N61165.AR.004217
CNC CHARLESTON
5090.3a

MISCELLANEOUS CORRESPONDENCE REGARDING RESOURCE CONSERVATION AND
RECOVERY ACT FACILITY INVESTIGATION CNC CHARLESTON SC
8/1/2001
CNC CHARLESTON

Figure 2-1
 Sample Soil Locations
 SWMU 38, Zone A
 Charleston Naval Complex

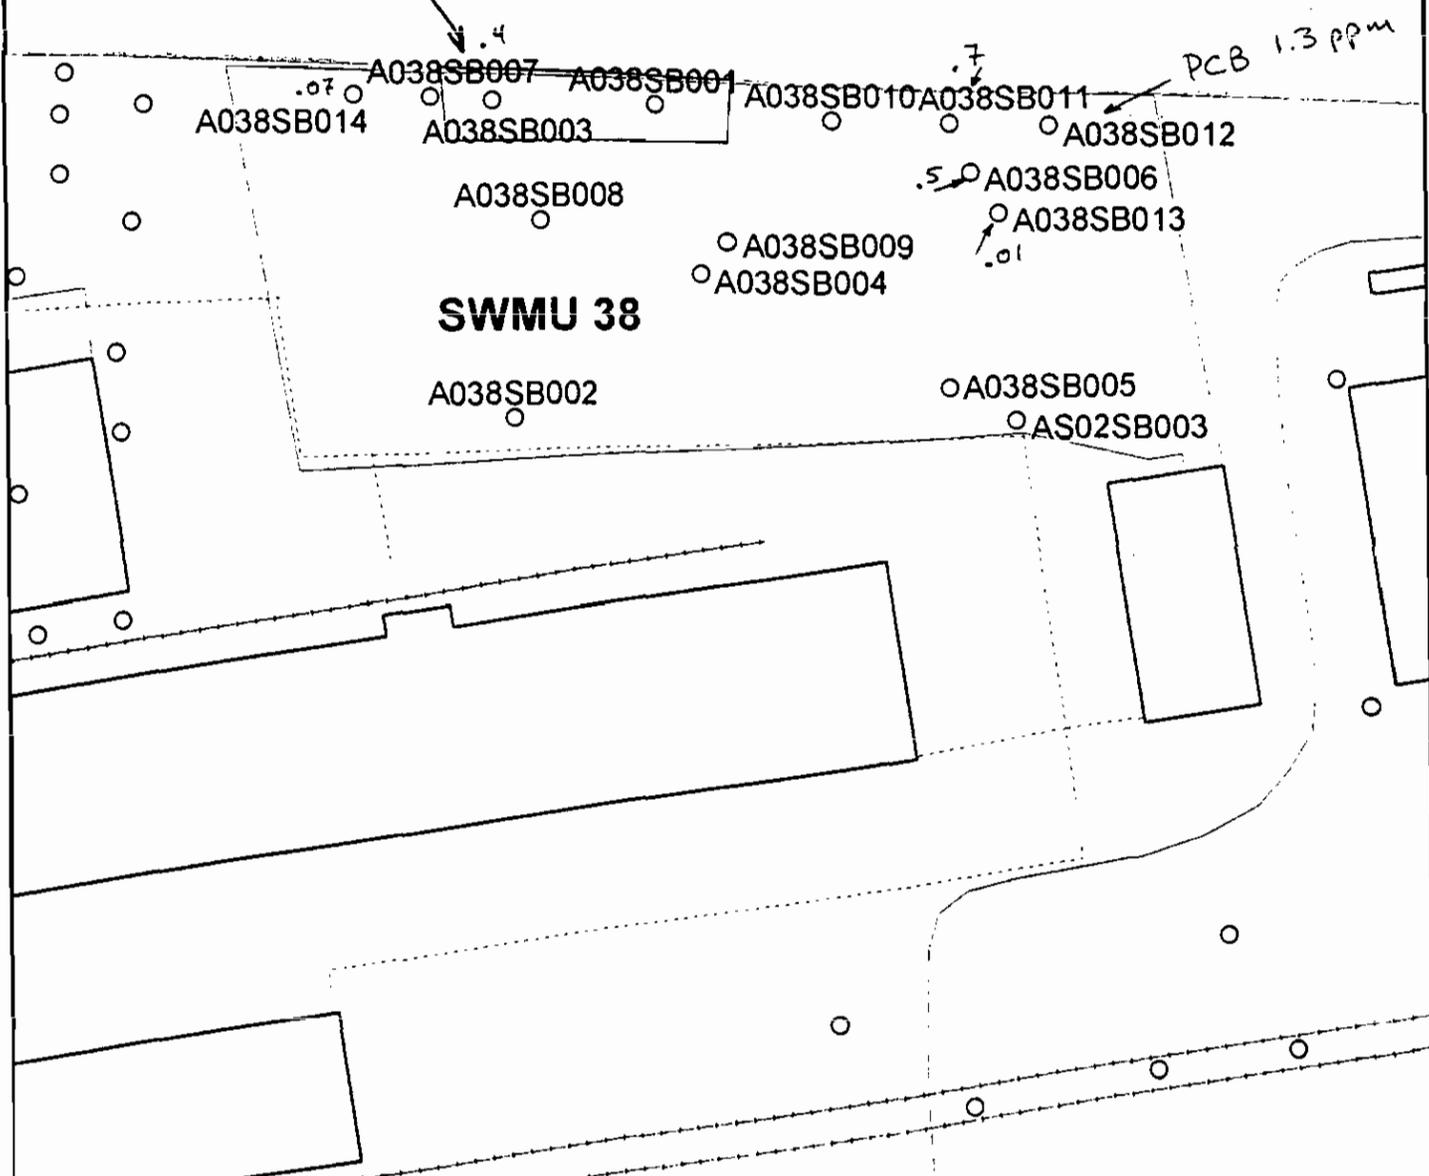
1. The referenced document is named, "CMS Work Plan Rational for No Further Action". This is not accurate. The goal stated within the document is to delineate the surface and subsurface soil contamination area and groundwater plume. The Navy and CH2MHILL acknowledged this error and therefore, the Department recommends the title change during the next revision or subsequent document (i.e., CMS Report).

2. Section 1.1. Background and Summary for CMS Work Plan. Page 1-1.
Lines 27-29 states that, "The Zone A RFI for SWMU 38 concluded that surface soil chemicals of concern (COCs) at SWMU 38 included several metals, polychlorinated biphenyl (PCB), and chlorinated pesticides; no COCs were identified." The last four words "no COCs were identified" appear to be out of context with the rest of the sentence. Please revise.

3. Section 2.0. Technical Basis and Rational for Interim Measures.
Please clarify what Interim Measures is being referenced here. The referenced document is a CMS work plan and not an interim measures. If the title is referring to the interim measures conducted by the Detachment in 1998, please clarify in the title of this section. Also, note that this section describes the previous RFI Report results and COC uncertainty analysis process.

4. Section 3.0. Interim Measures Work Plan.
Please change the title of this section to CMS Work Plan or clarify what interim measures are being referred to. Please be consistent in naming the referenced document. Either it is an interim measures or CMS Work Plan, and according to the discussion with CH2MHILL the referenced document is a CMS Work Plan.
